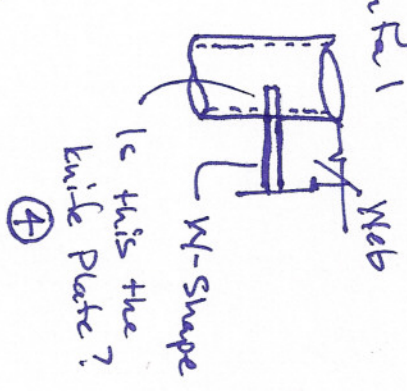
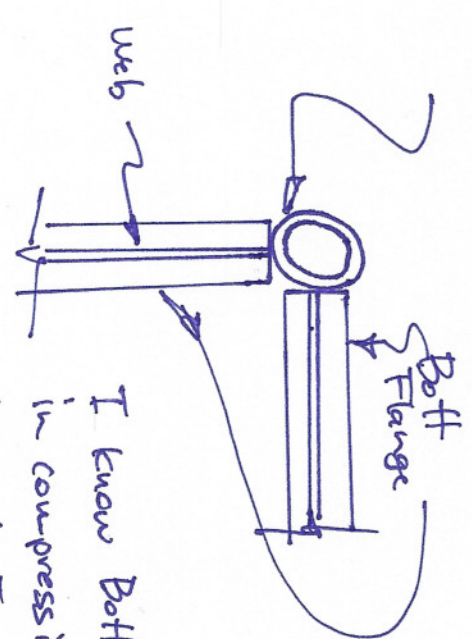
I may be looking @ the knife plate wrong - should it be horizontal!

① Not sure how to size this??

② Connection @ Bolt Flange seems odd - Advice?

Is this the knife plate?

I know Bolt Flange is in compression, but how do I check to see if Pipe is adequate there? ③
